Re: Cherokee Nation WW Hastings Replacement Hospital - Addendum 02 Narrative

Following is a list of revisions included in Addendum 02.

PROJECT PHASE:
BID PACKAGE 02
(SITE DEMOLITION AND UTILITIES)

JOB NUMBER: 21-08.21
DATE: 10-21-2022
SHEET NUMBER:
C4-101
SHEET TITLE:
OVERALL UTILITY VIEW

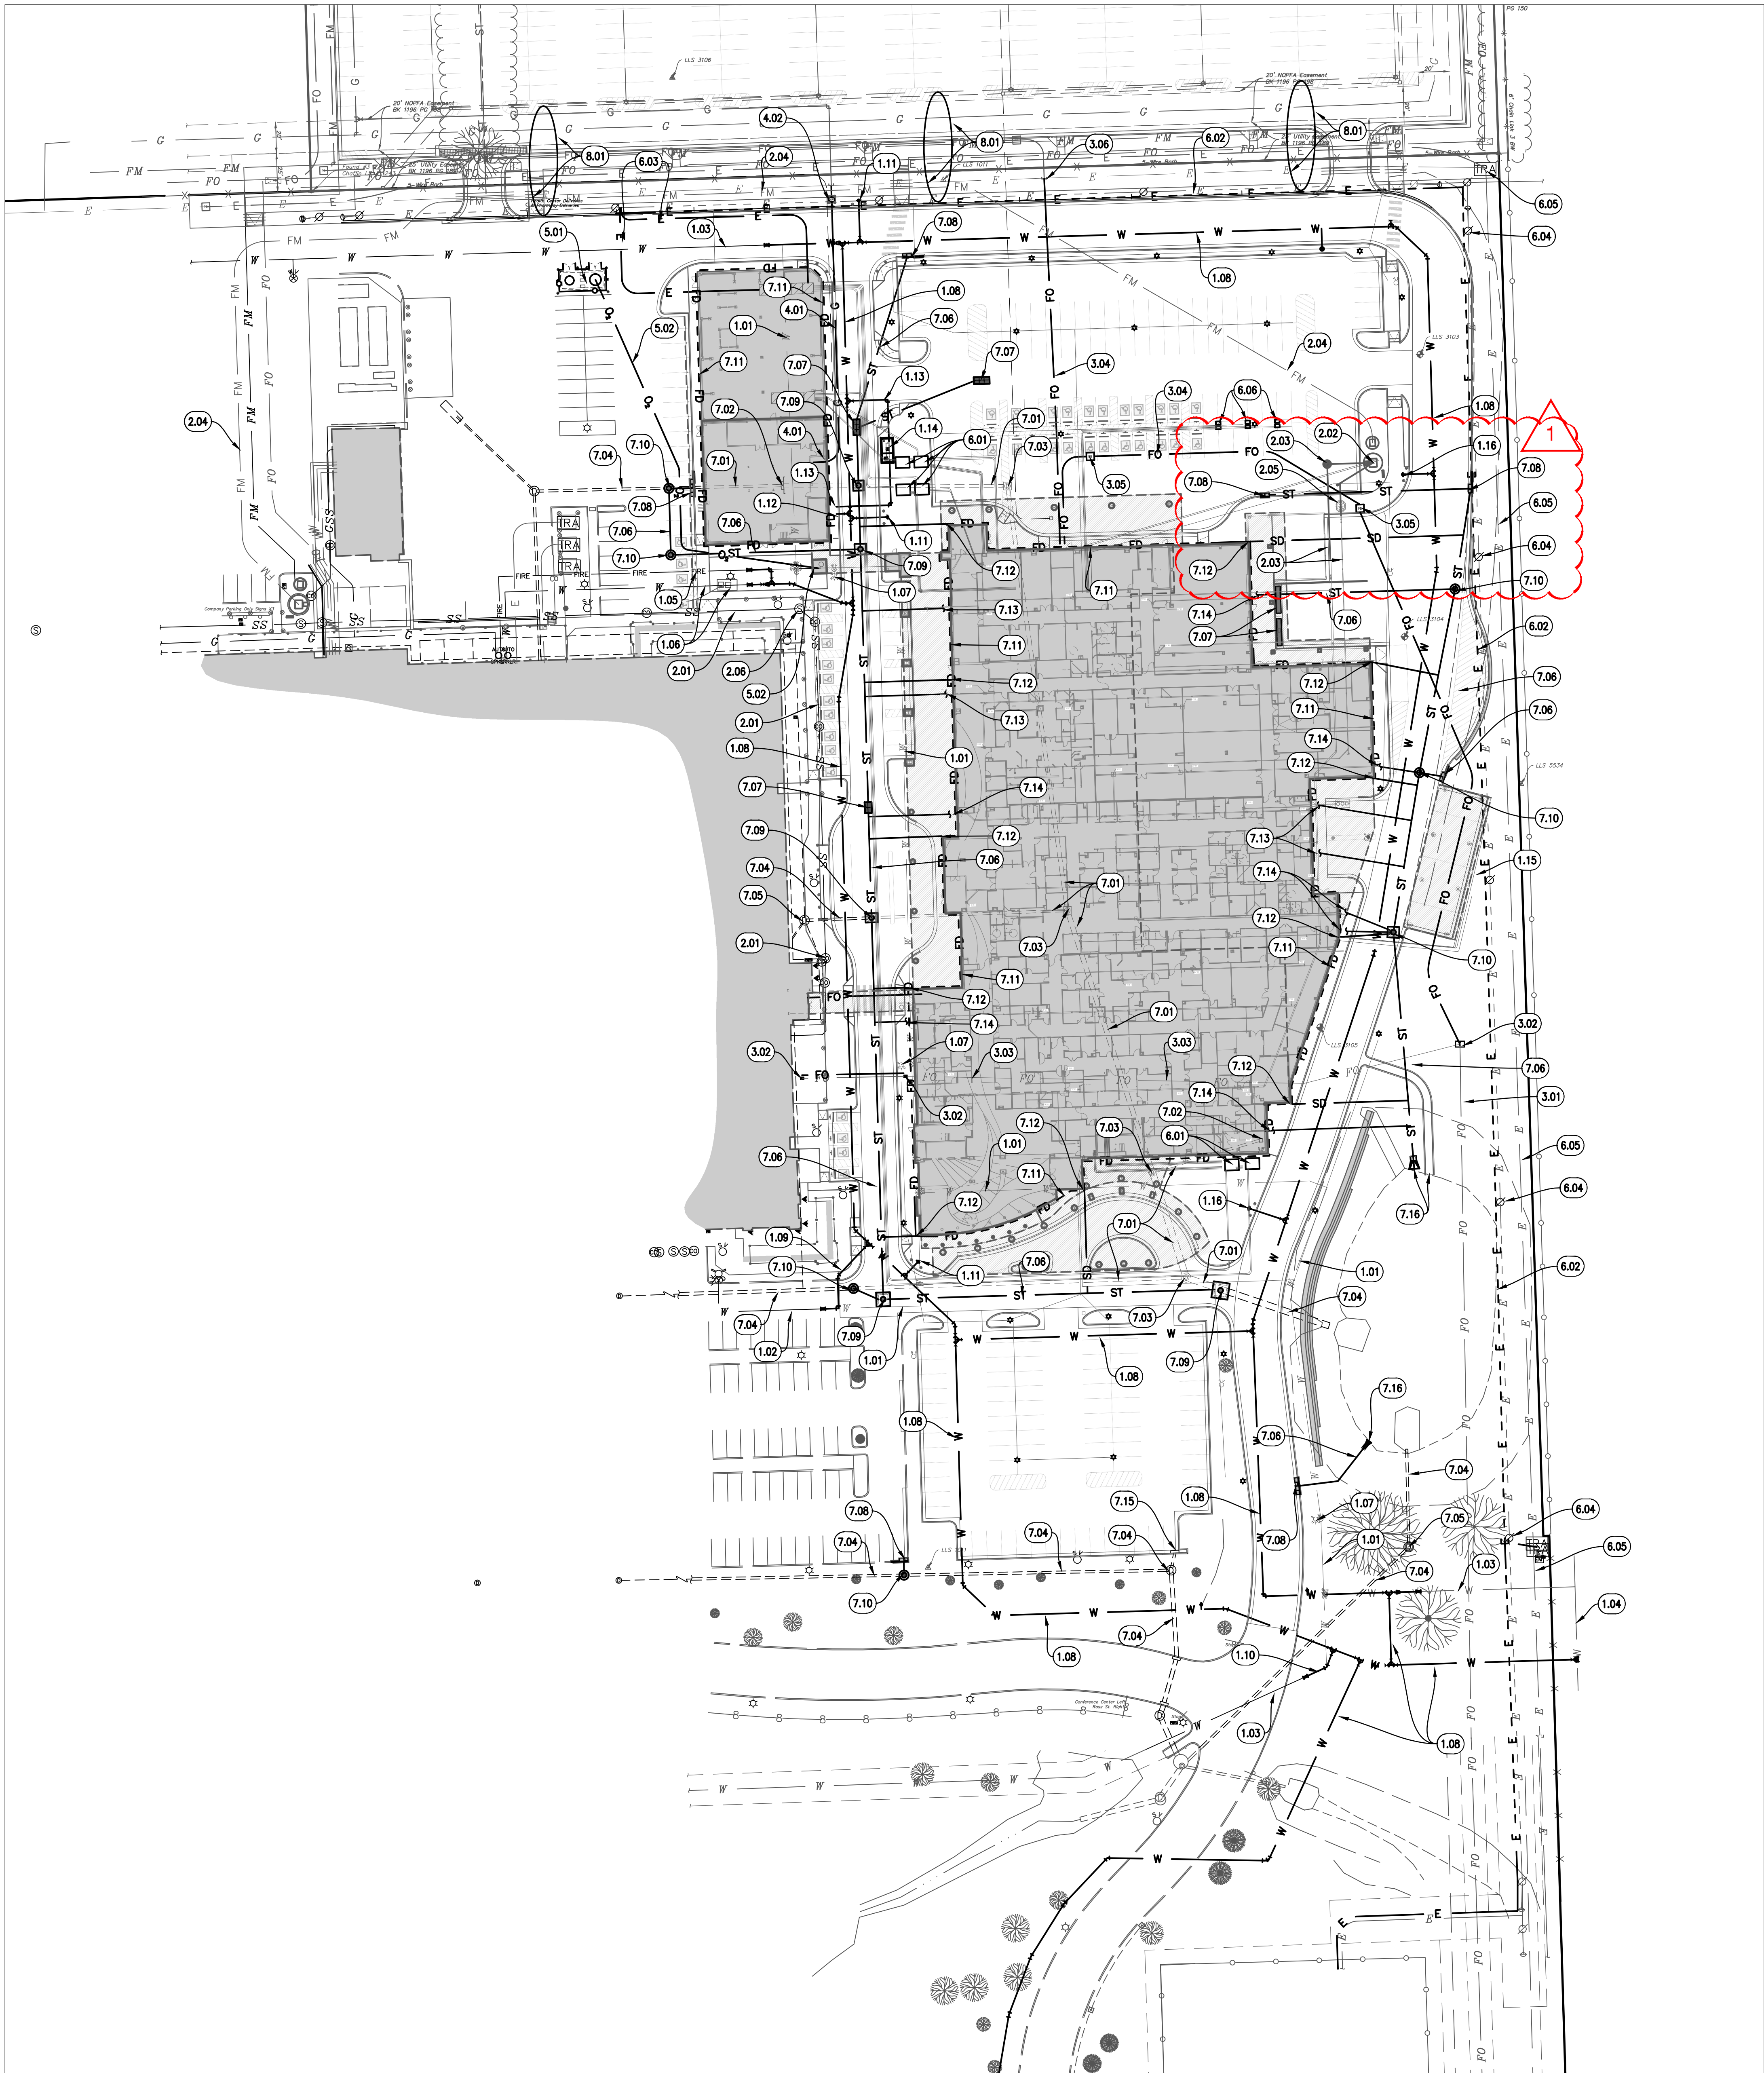
- C0-101 - Updated sheet list with new sheet C4-901.
- C4-101 - Updated utility plan with grease trap location, new storm sewer inlet, and sanitary sewer manhole.

SHEET NUMBER:
C4-901

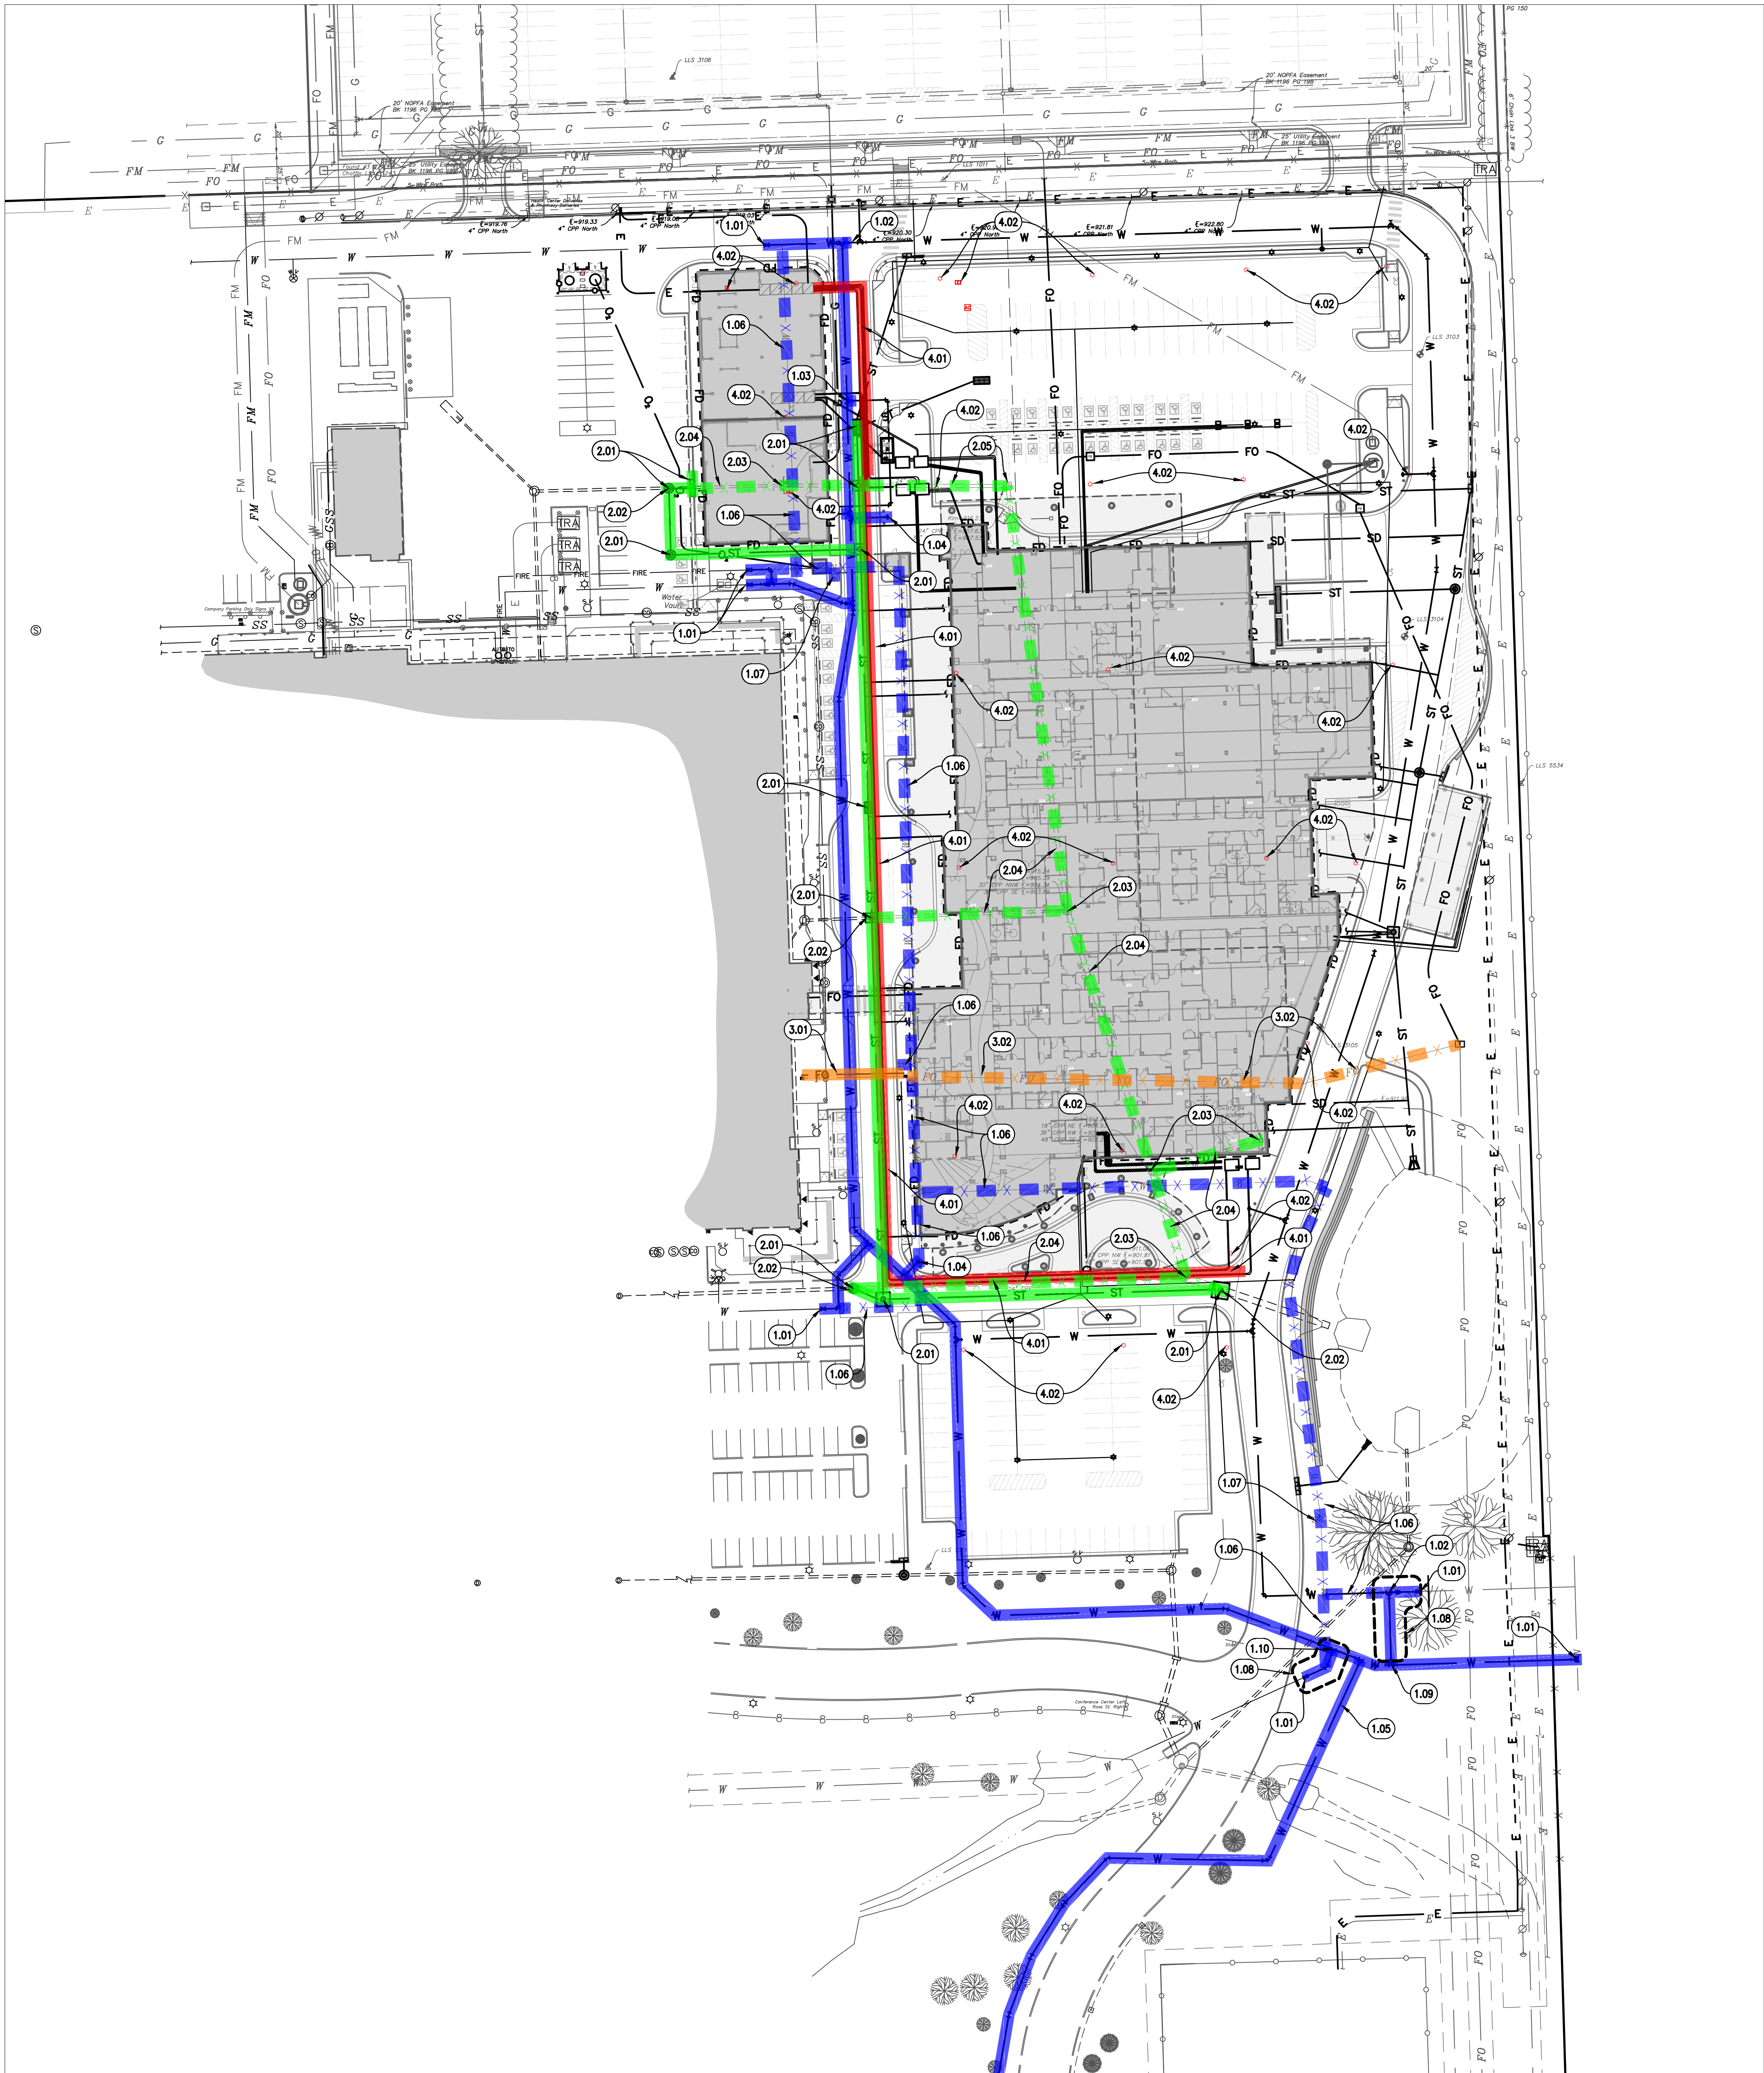
- C4-103 - Updated utility plan with grease trap location, new storm sewer inlet, and sanitary sewer manhole.
- C4-901 - New Sheet – Phase 1 Utility Plan.

C6-101

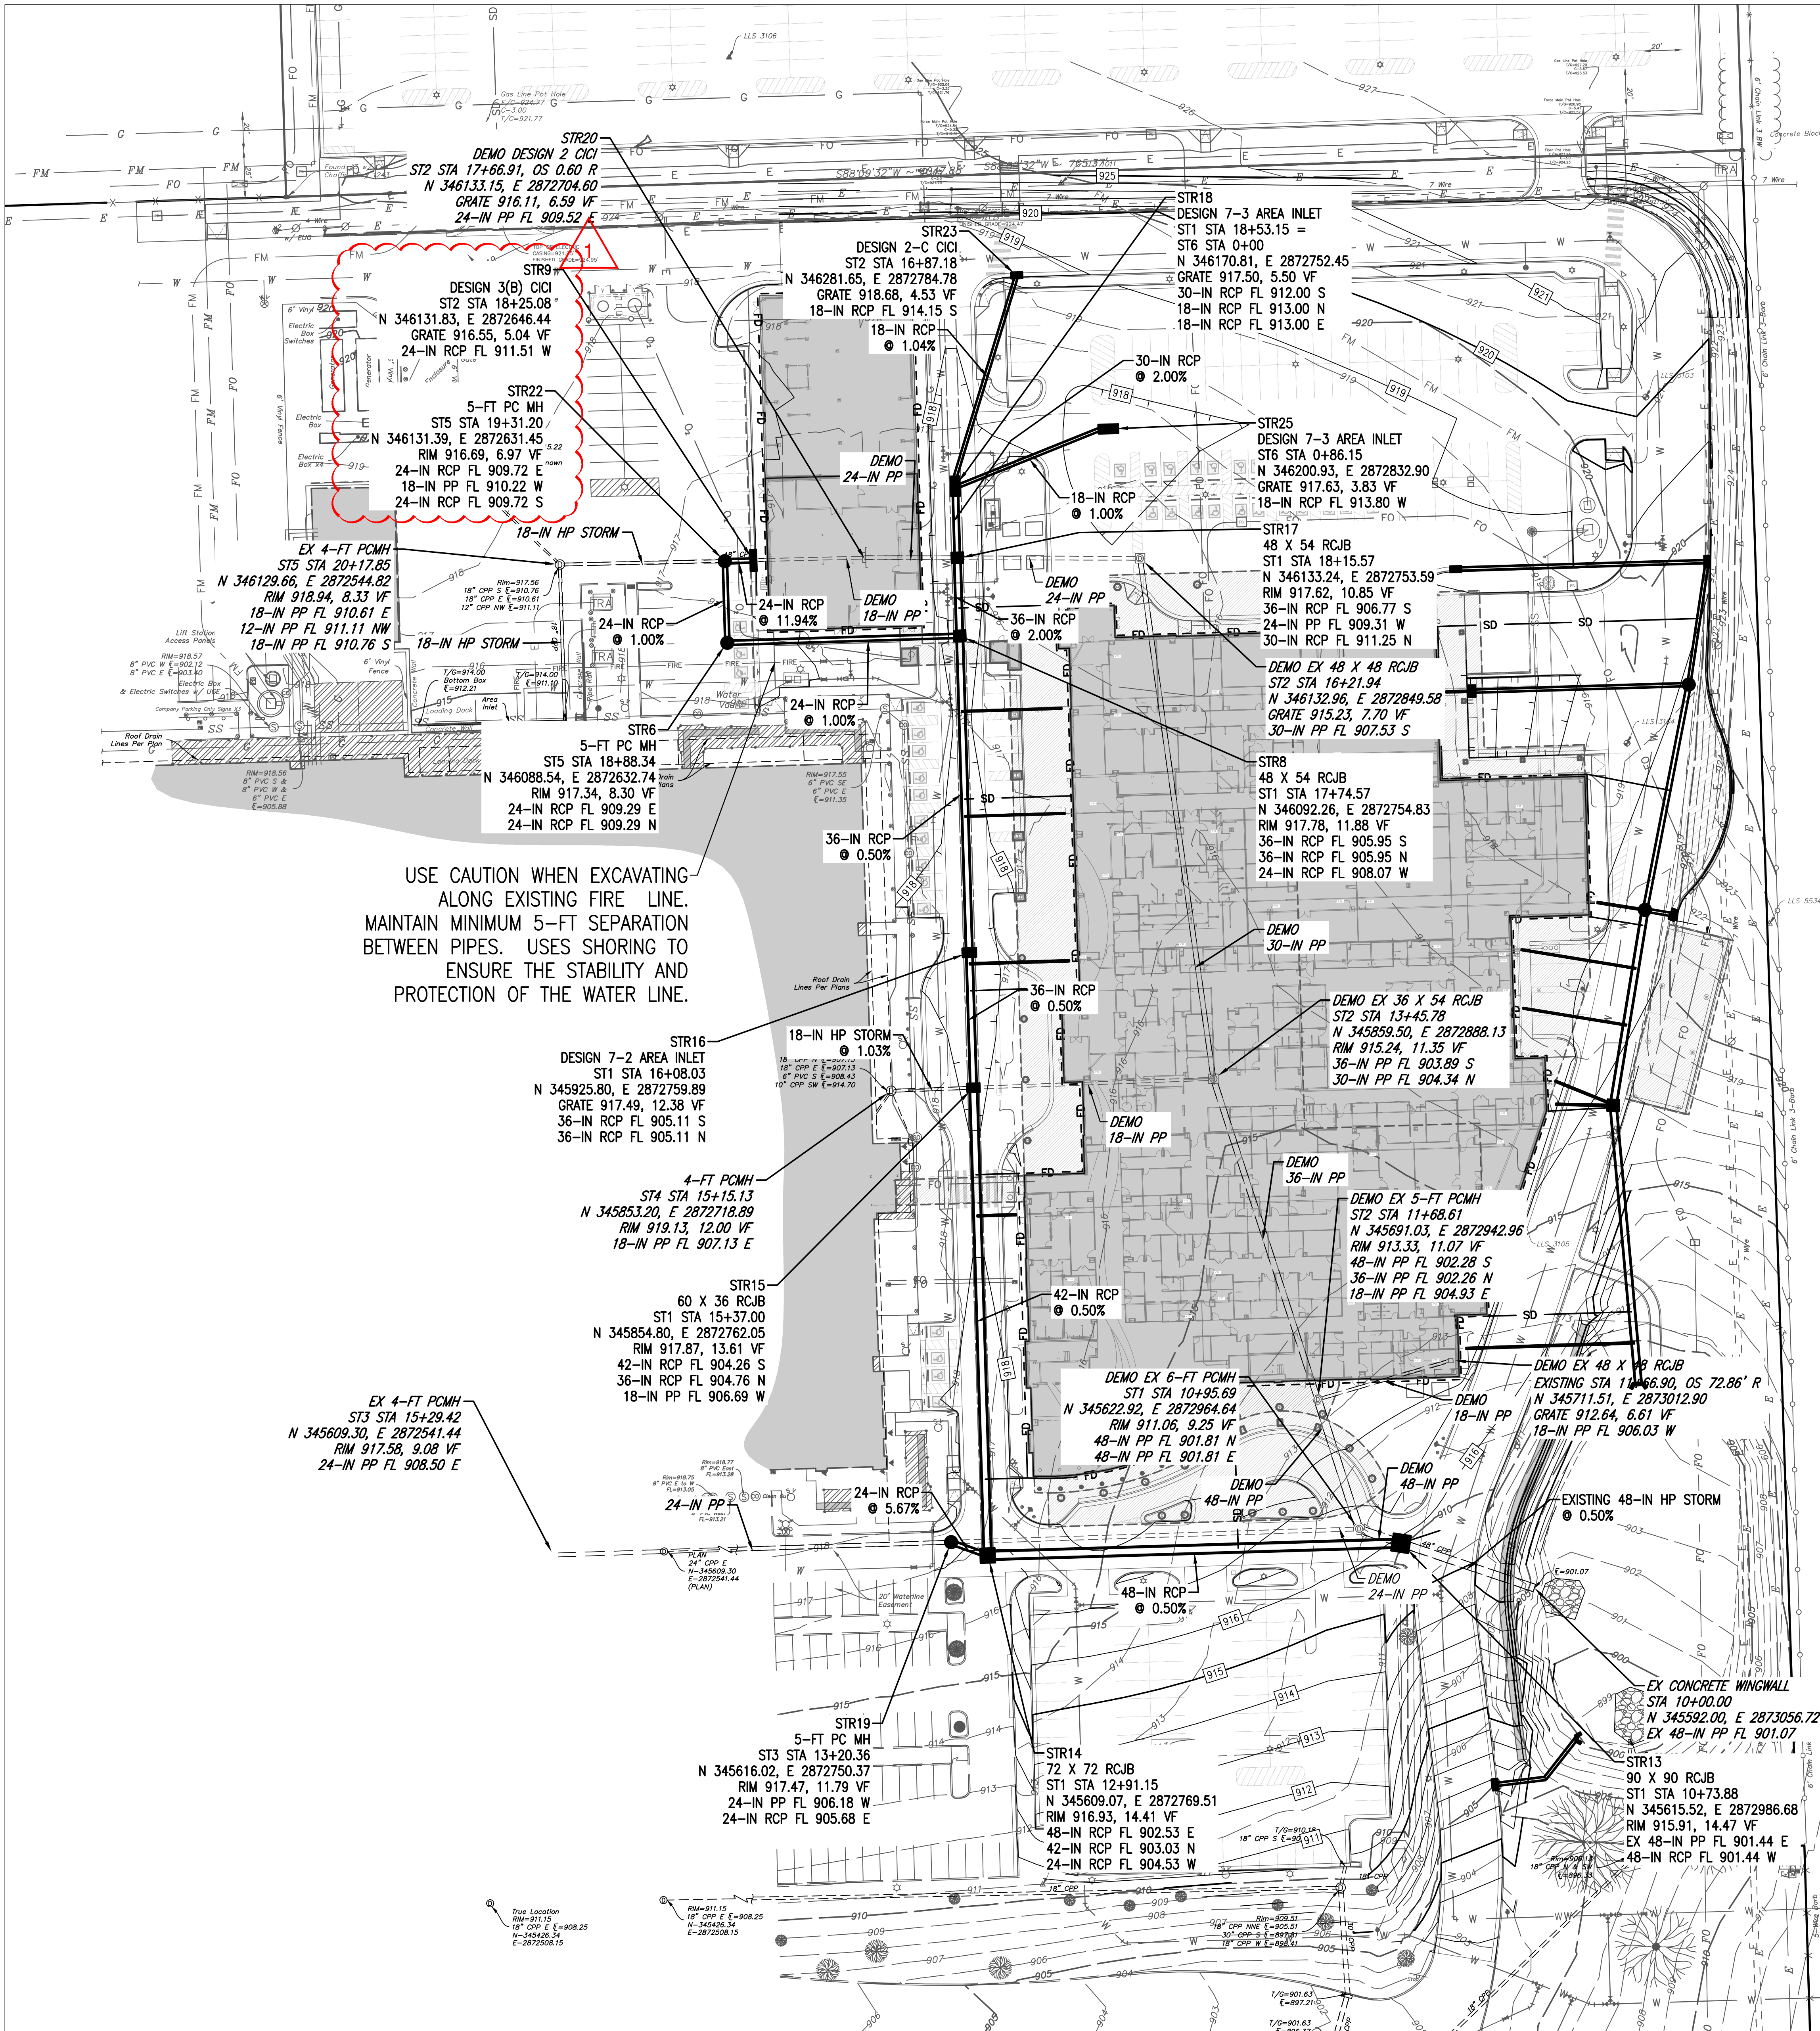
- C6-101 - Corrected grate elevation on STR9.
Corrected STR22 to connect the existing storm sewer pipe to the manhole.
- C6-102 - Added STR38 inlet north of the hospital.
The flow lines of the pipes from STR28 to STR31 were lowered so that drainpipes on the upstream end can pass under the 16-in water line.
